Subject: **Response to DWQ on Hold Letter** for the permit application for the new construction of the High Point East Beltway, US 311 from south of US 29/70 to US 220, in Guilford and Randolph Counties, TIP R-609IA, IB, and R-2606A, B, and C.

Reference: R-609IA, IB, R-2606A, B, and C, Permit Application, submitted February 28, 2006
DWQ On Hold Letter, DWQ# 06-0331, Dated April 24, 2006

R-0609IA Stream Restoration Site – Natural Channel Design for Mile Branch

Natural Channel Design Methodology (from Rosgen D-120)

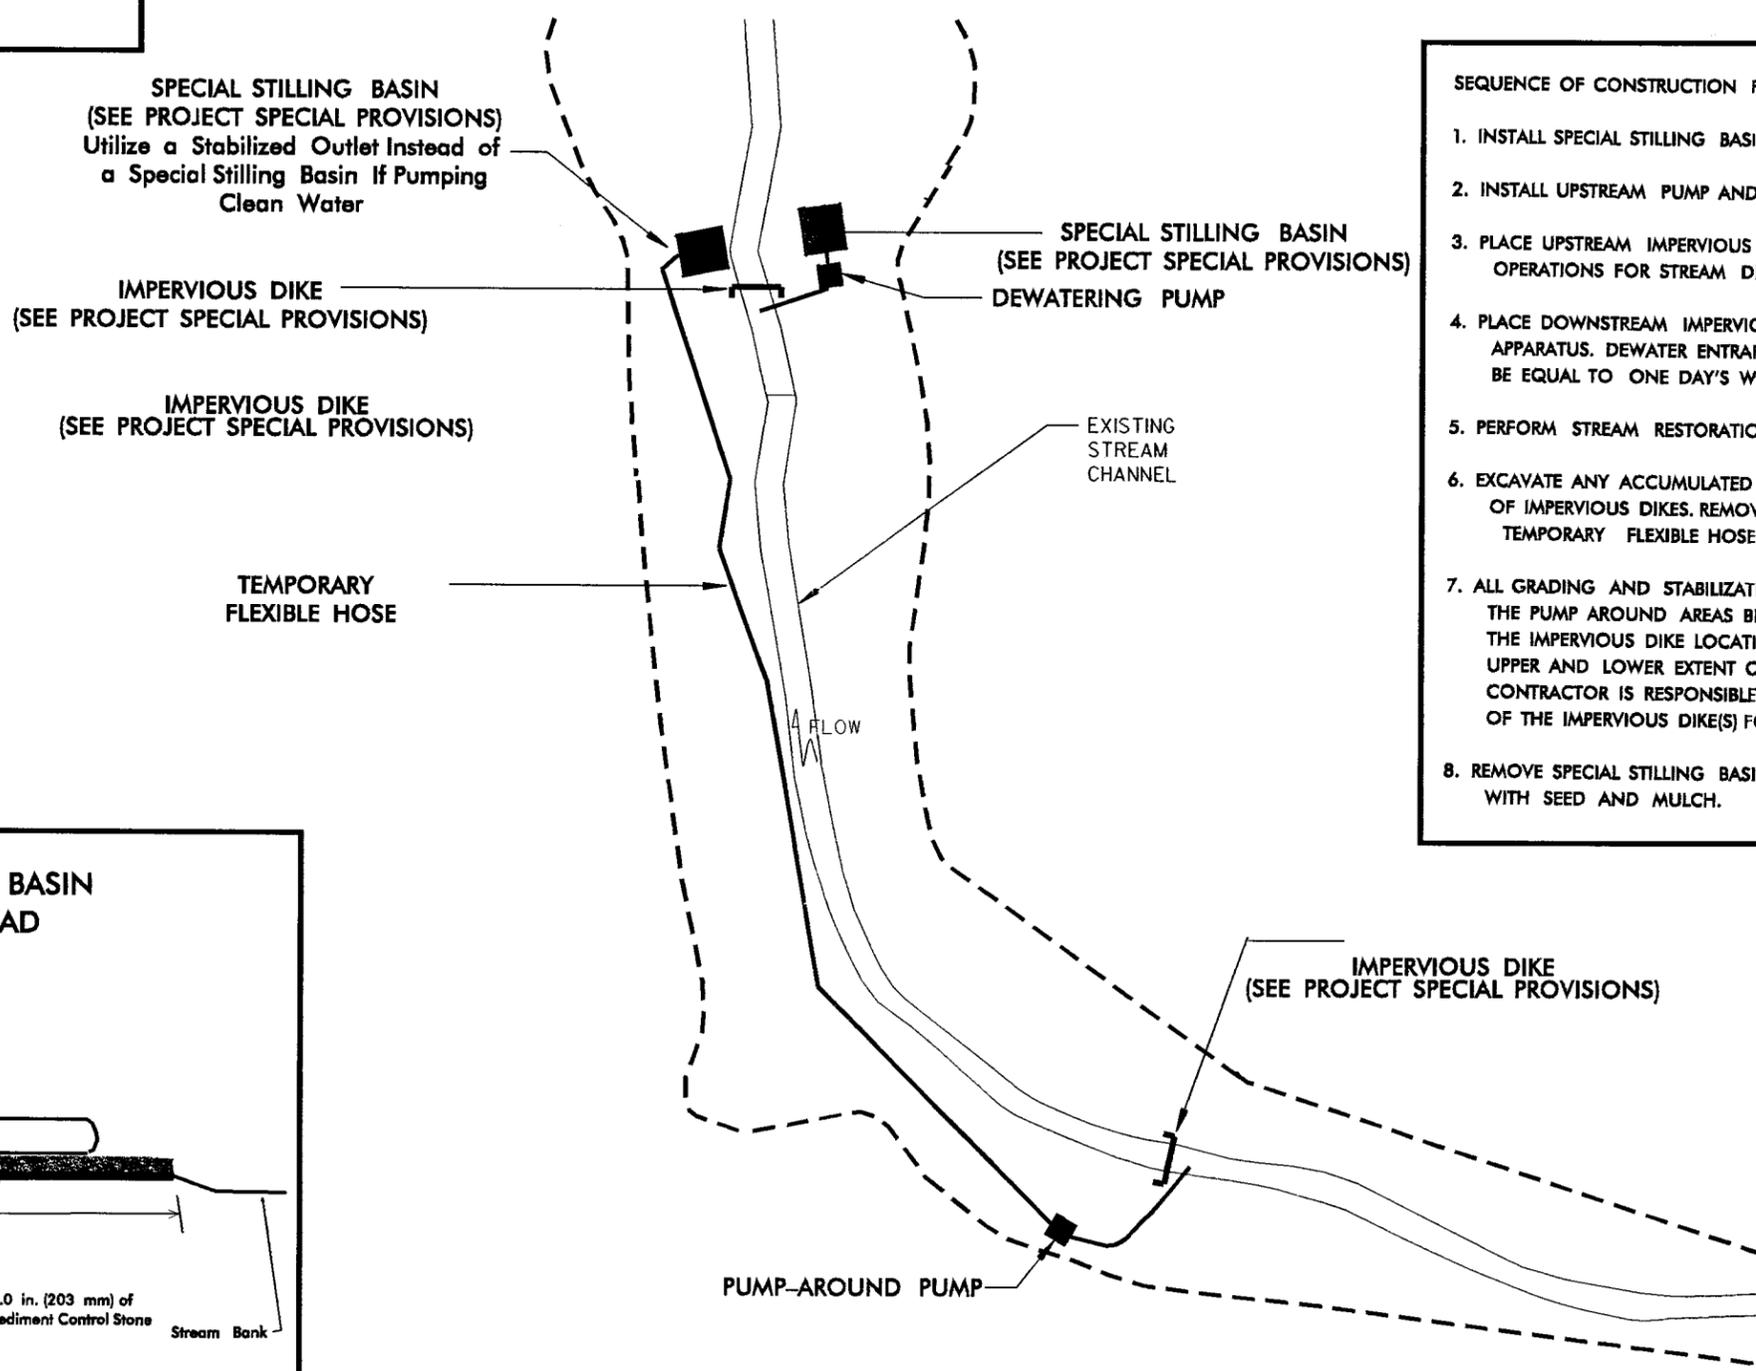
- *Please provide predictive sediment transport computations for this natural channel design.*

Attached is a spreadsheet showing the calculated shear stress and the size of particle that needs to be moved. (See line 45)

EXAMPLE OF PUMP-AROUND OPERATION

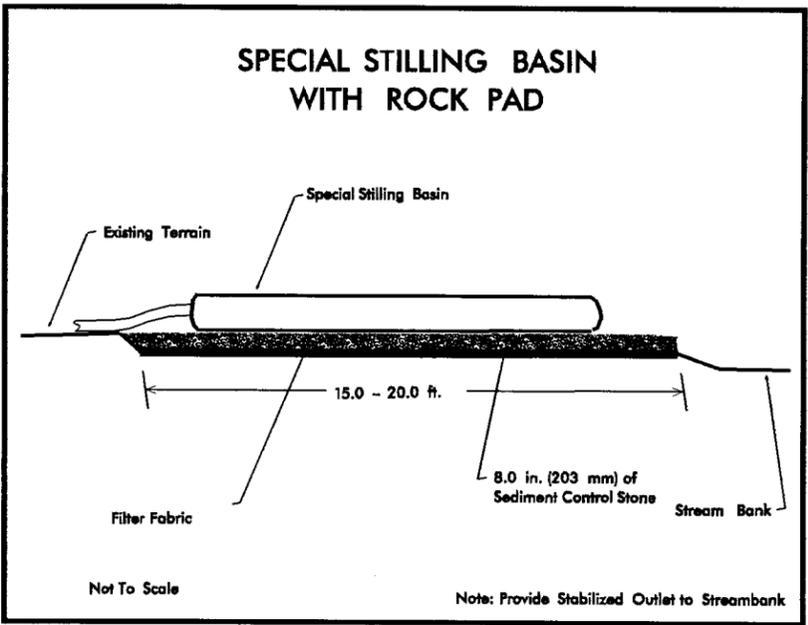
- *The Division's policy is that stream relocations be constructed "in the dry" and stabilized before water is turned into them. Please explain how the new channel will be constructed given its location is directly across the two tributaries that enter the channel in this location.*

The channel from approximately 10+40 to 11+40 can be constructed while the flow is maintained in the existing channel. The remaining portions of the channel will have to be constructed utilizing a pump around operation. By using the pump around operation, the flow will have to be turned back in the channel at the end of each workday. The pump around operation will be limited to the amount of channel that can be constructed within one working day. The channel will be seeded and mulched and coir fiber matting will be installed prior to water being turned into the channel at the end of each workday. Attached is a detail for the pump around operation.

PROJECT REFERENCE NO.	SHEET NO.
R-06091A	EC-68A/CONST.29
R/W SHEET NO.	
ROADWAY DESIGN ENGINEER	HYDRAULICS ENGINEER

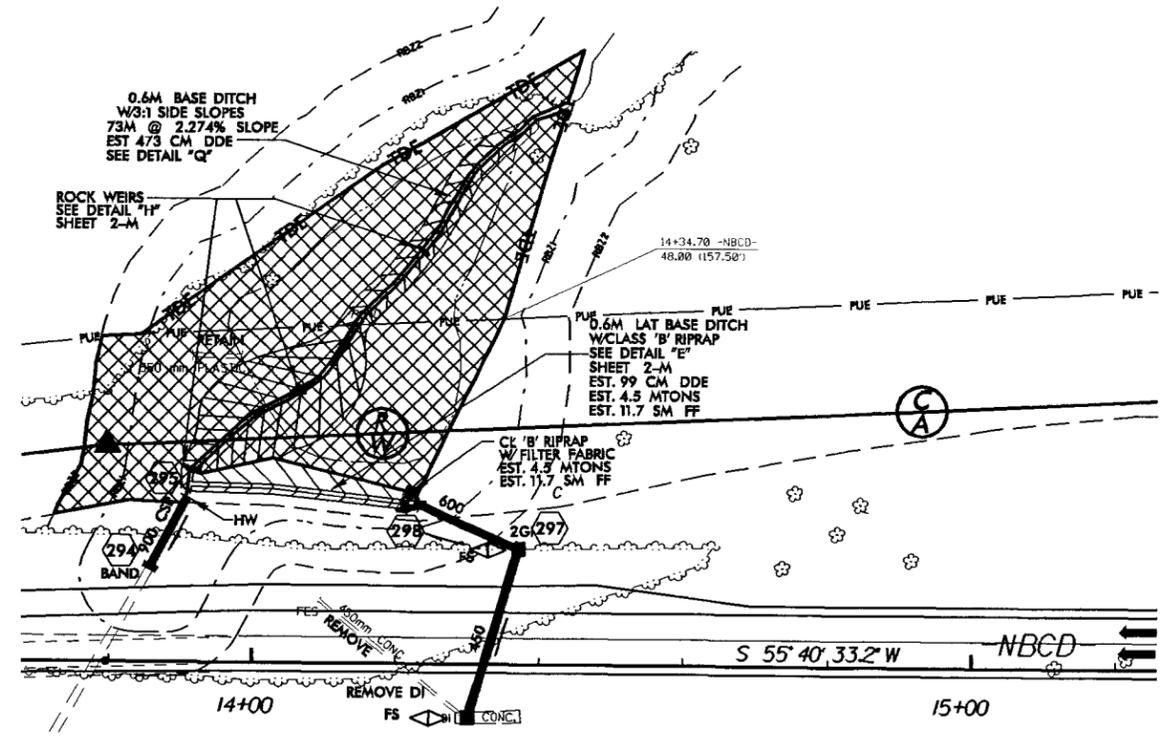
- *The channel profile shows a straight channel bottom. Please provide a plan and profile that accurately depicts the designed streambed characteristics (pools, riffles, runs, glides, structures, etc). The contractor should have drawings that indicate every facet of the natural channel to ensure it is constructed in a manner that will remain stable.*

- *The two small tributaries that will be entering the new channel join the main channel at sharp angles. This will increase stress on the far banks. Please provide computations or explanations that document the proposed tie in locations will not cause channel instability, or relocate the tie-ins.*

The profile has been revised to show channel features.

The tributaries have been adjusted to tie in at the outside bends. The location of the tie-ins will be at pools and will allow the energy to be dissipated in the pools.

PROJECT REFERENCE NO. R-06091A	SHEET NO. RF-2
R/W SHEET NO.	
ROADWAY DESIGN ENGINEER	HYDRAULICS ENGINEER

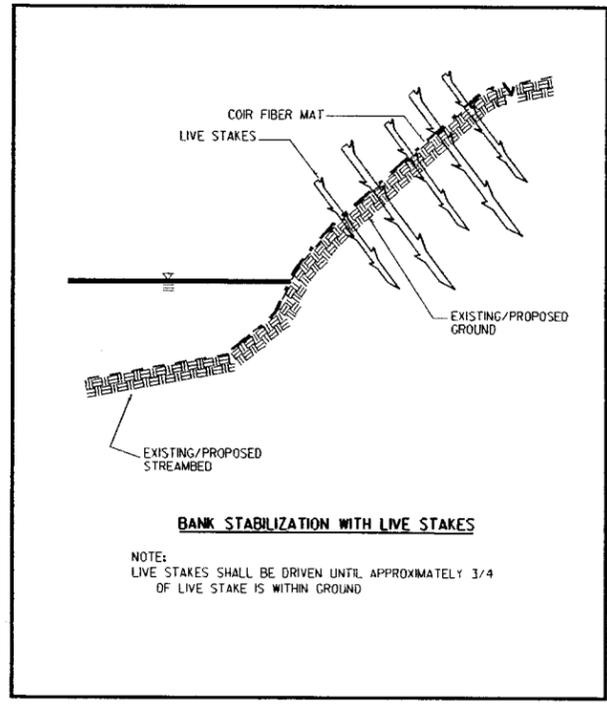
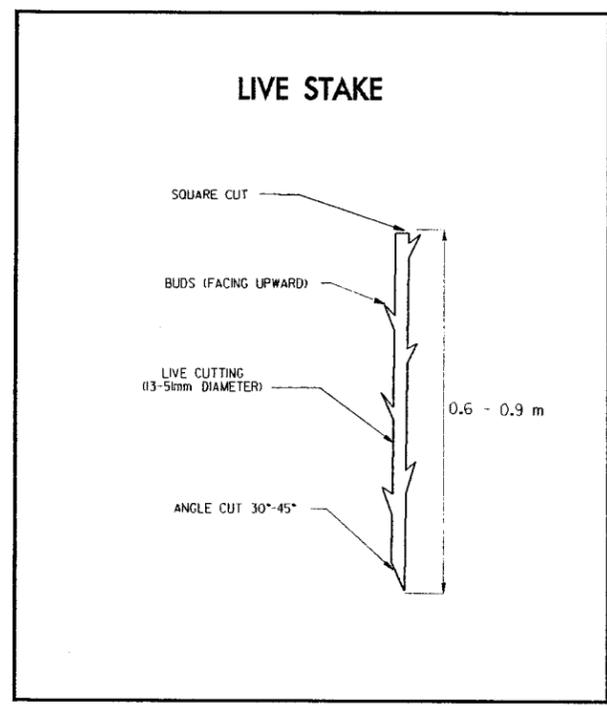
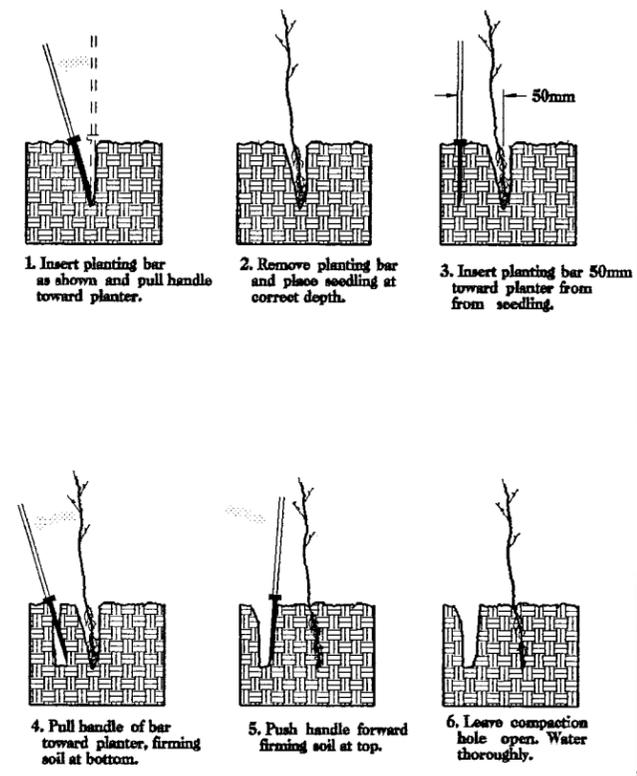
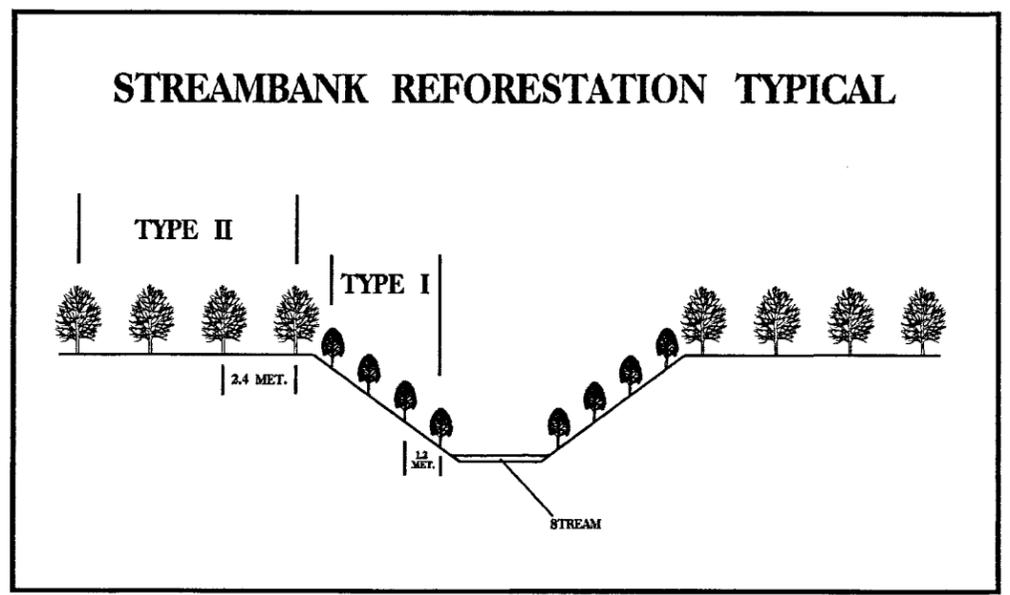
- *Please provide a detailed streambank and buffer reforestation plan.*

A streambank and buffer reforestation plan has been included with this letter. The following components of Level 1 monitoring will be performed each year of the 5-year monitoring period: Reference photos, plant survival (i.e., identify specific problems areas (missing, stressed, damaged or dead plantings), estimated causes and proposed/required remedial action); visual inspection of channel stability. Physical measurements of channel stability/morphology will not be performed. A monitoring report will be submitted within sixty (60) days after completing the monitoring.

PROJECT REFERENCE NO.	SHEET NO.
R-2606	L3A
DESIGN ENGINEER

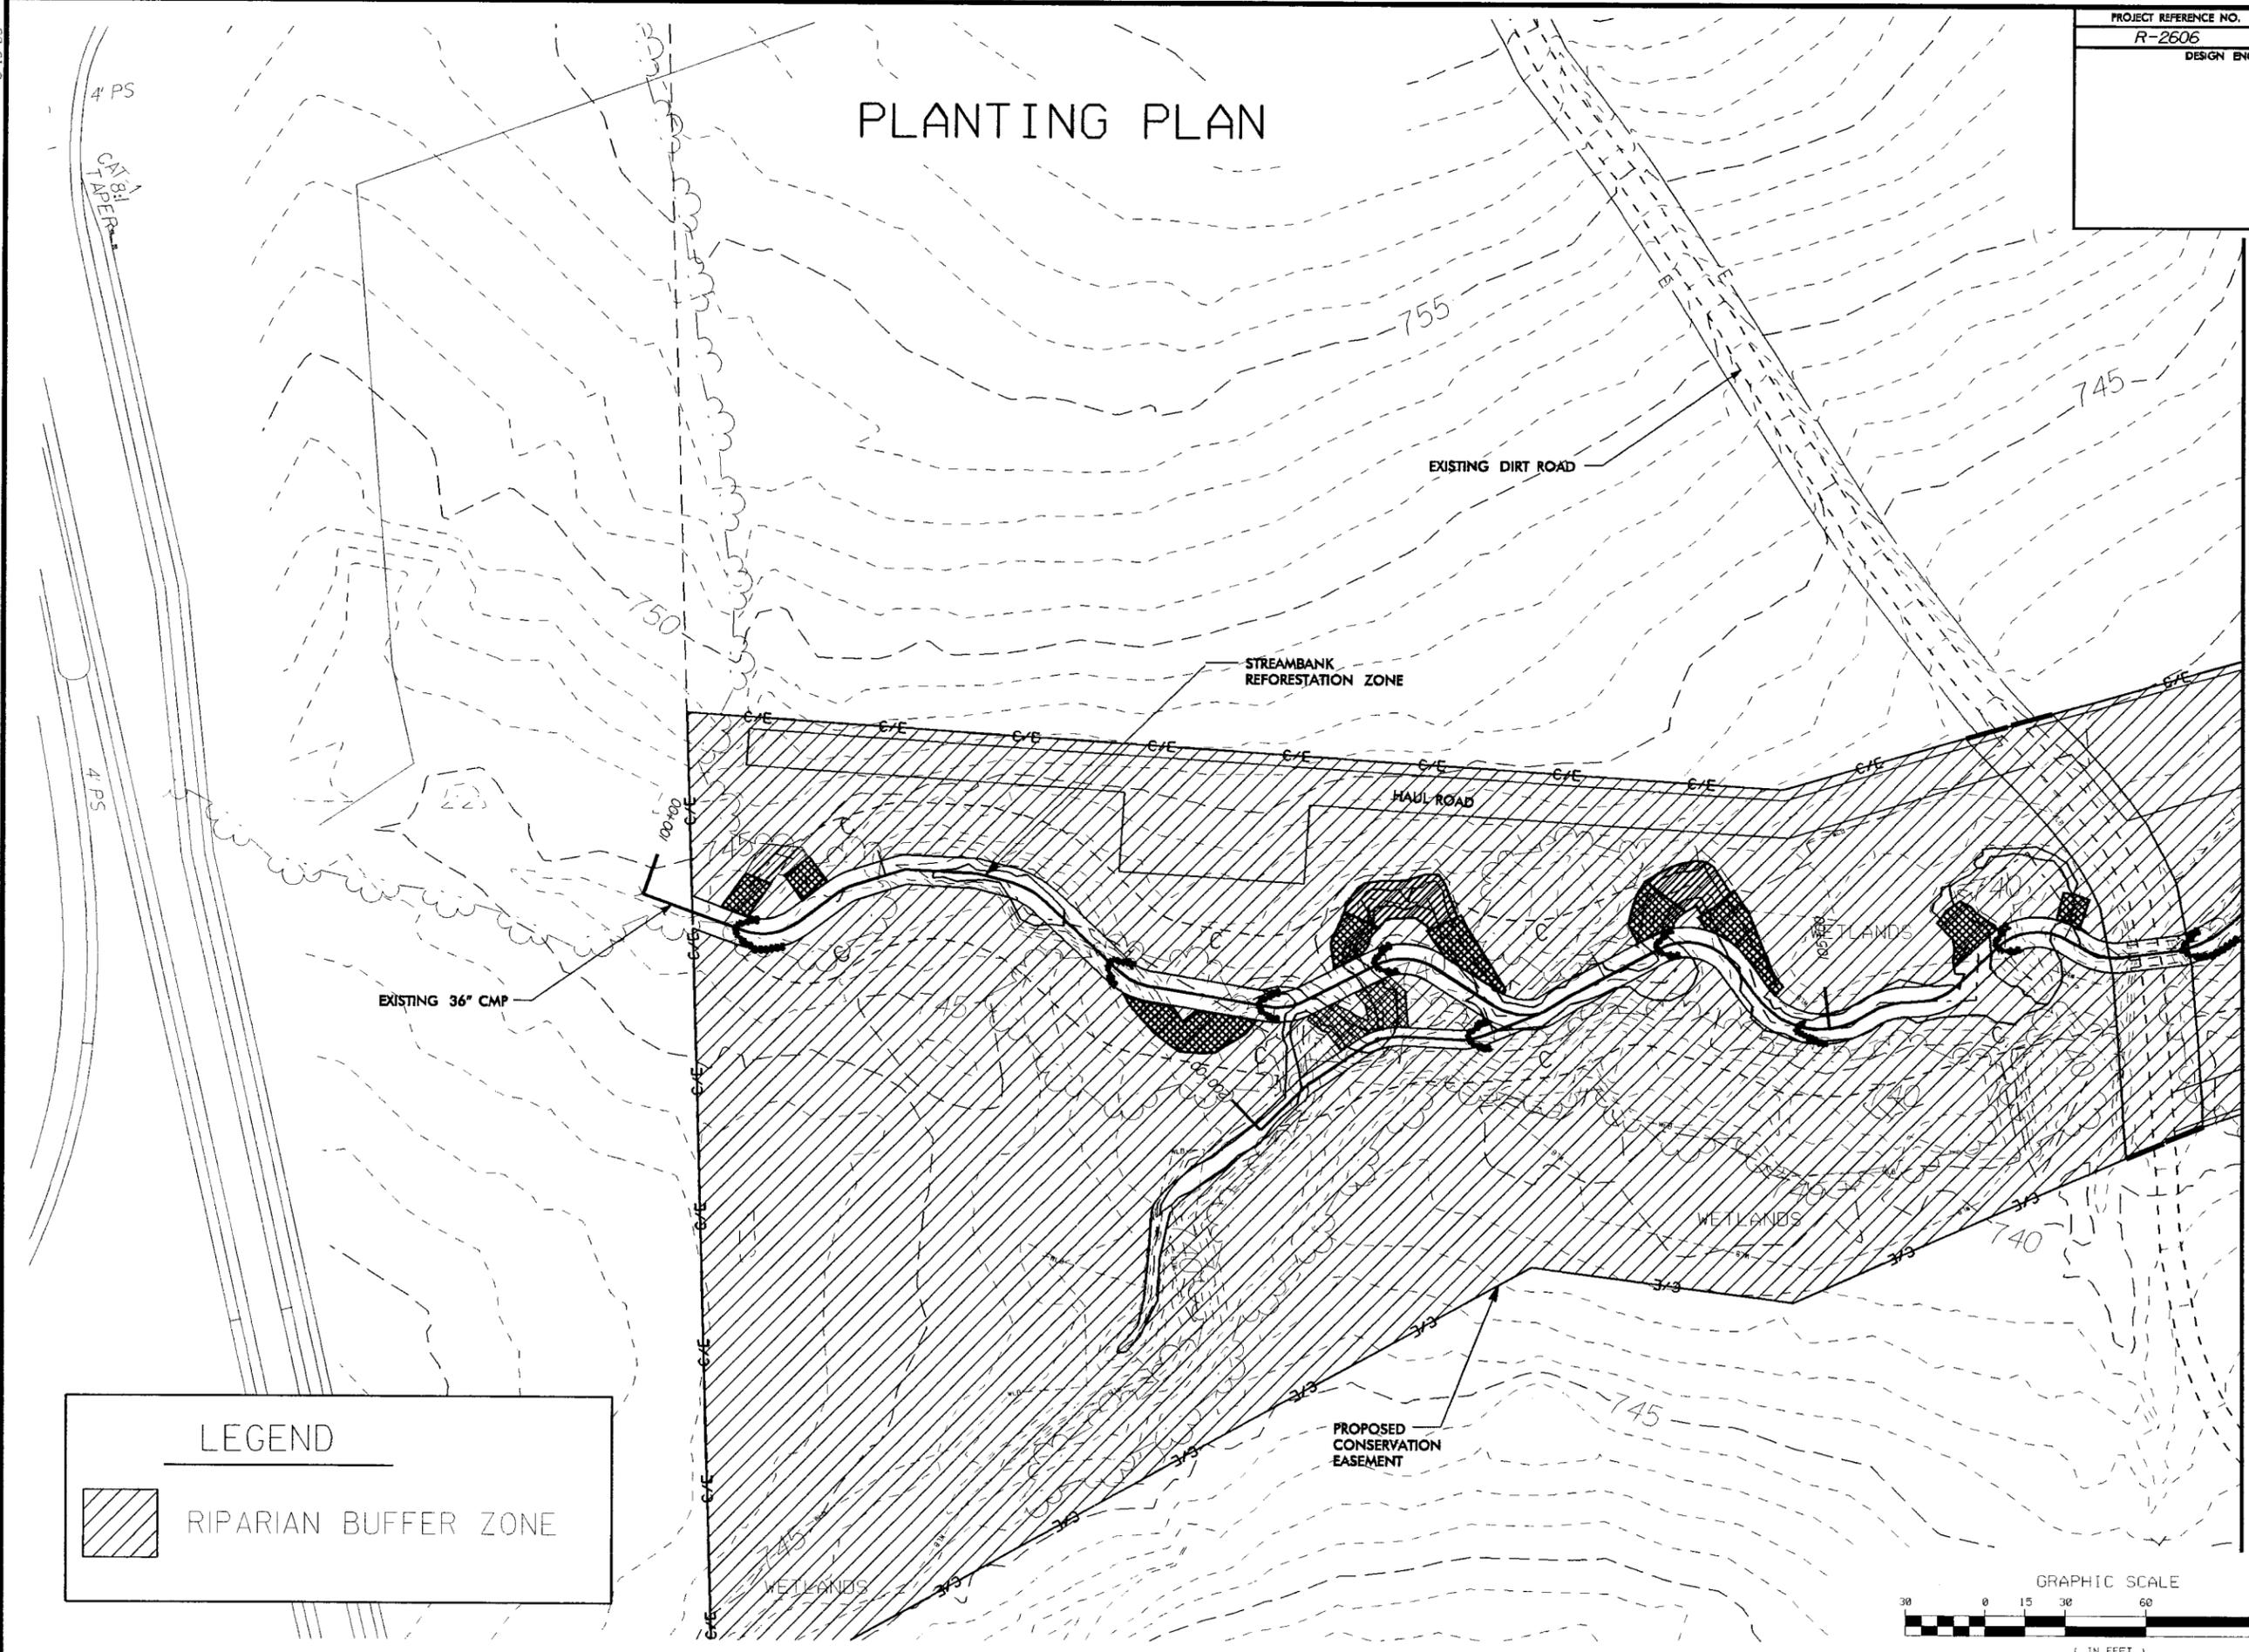
Additional information on the project was also requested by DWQ for the subject project. In an email from Sue Homewood dated October 26, 2006, a request was made for a planting plan for both the R-2606A and R-0609IA stream restoration sites as well as the total square feet of buffer Zone 1 and buffer Zone 2 plantings. The planting plan needs to show the specific areas that will be planted on both sites. NCDOT has attached planting plans for both sites. Per the detail sheet for streambank reforestation, Type I planting includes live stakes and will be planted on the stream banks. Type II plantings are bareroot seedlings and will be planted in the hatched areas shown on the plan sheets.
